16 December 2005

SUBJECT: Response to Agency Comments on Aerojet's Preliminary Response to Agency Comments, February 2005 Final Perimeter Groundwater Operable Unit Remedial Investigation/Feasibility Study

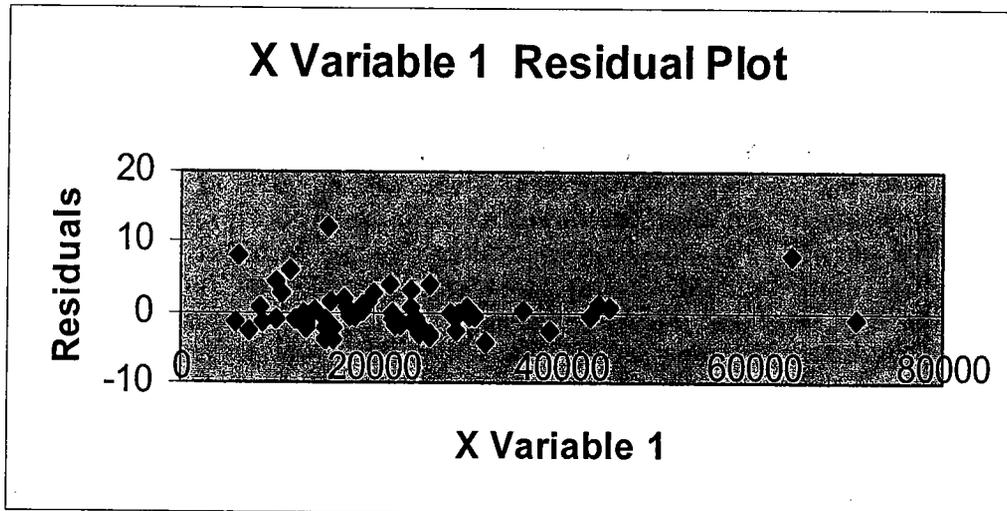
Original Comment 163. Aerojet asserts that arsenic and aluminum concentrations are correlated with one another, and that this correlation is represented by the concentration plot in section "Response to Specific Comment 163". The statistical analyses are inadequate to support this assertion, and the regression technique is not appropriate to determine correlation. Regression analysis requires the residuals to be normal. The variance of the residuals should also be constant (e.g., so that when the residuals are plotted versus X or Y, the degree of scatter is relatively uniform). However, plots of the residuals were not included. Residual plots need to be included when regression analysis is performed.

Data are not sufficient to support the assumption that all chromium is present in the trivalent form. Considering the differences in risk associated with exposure to trivalent versus hexavalent chromium, hexavalent chromium analysis needs to be performed on each sample. Aerojet needs to provide additional information that presents the frequency of detection of hexavalent chrome at similar sample locations within the PGOU to make the case that trivalent chromium PRG should be selected.

Response Aerojet presents the following information to support the assertion that arsenic and chromium are not contaminants of concern within the PGOU:

The statistical analysis was just one aspect of the overall evaluation of arsenic. In the response to the original comment, Aerojet demonstrated that only two relatively high arsenic levels were identified as "far outliers" in the overall PGOU dataset, and these values could not be verified as representing elevated arsenic conditions at the site. In one case, repeat sampling at the same

location failed to confirm the elevated arsenic. In the second case, the sample was identified as an outlier based on an elevated detection limit and evaluation of sample data from the same location at shallower depths failed to confirm the presence of elevated arsenic.

The samples with positive detections of arsenic show an overall correlation with aluminum levels, as would be expected from the natural association of this metal with aluminum in clay minerals. A residual plot is provided as follows:

The residuals generally deviate from a normal distribution, as can be seen by several of the samples with higher than expected arsenic at both the low and high end of the aluminum range. However, the data are still highly correlated based on a nonparametric Spearman Rank Correlation test. Therefore, the statistical analysis confirms that arsenic is correlated with aluminum and the few elevated detections at the site represent natural substrate variation rather than contamination.

With regard to chromium, the comment seems to incorrectly state that hexavalent chromium data are insufficient to evaluate risk. Hexavalent chromium data were collected concurrently with total chromium not only for the single sample from Site C15 that exceeds the total chromium PRG, but for all RI samples collected in 2003. Out of 34 samples collected at various locations and depths, hexavalent chromium was only detected above the PQL in five samples, with a maximum concentration of 1.1 mg/kg in a sample from Site C4. The maximum concentration of hexavalent chromium is well below the residential PRG of 30 mg/kg. Additionally, hexavalent chromium was not detected in any of the four samples collected at Site C15 in 2003, including the single sample containing chromium above the total chromium PRG. The maximum percentage of hexavalent chromium in any soil sample is 2.1% which was in the sample collected at Site C4 having the maximum hexavalent chromium concentration. This is well below the 1:6 ratio of hexavalent to trivalent chromium assumed for the derivation of the total chromium PRG. Therefore, Aerojet asserts that the data are sufficient to show that hexavalent chromium does not pose a risk in soil at sites within the PGOU. Additionally, Aerojet believes that it would be inappropriate to compare total chromium concentrations to the total chromium PRG since the data indicates that 97.9% or more of the total concentration of chromium is trivalent chromium, not the 1:6 ratio of hexavalent to trivalent chromium assumed for the PRG.
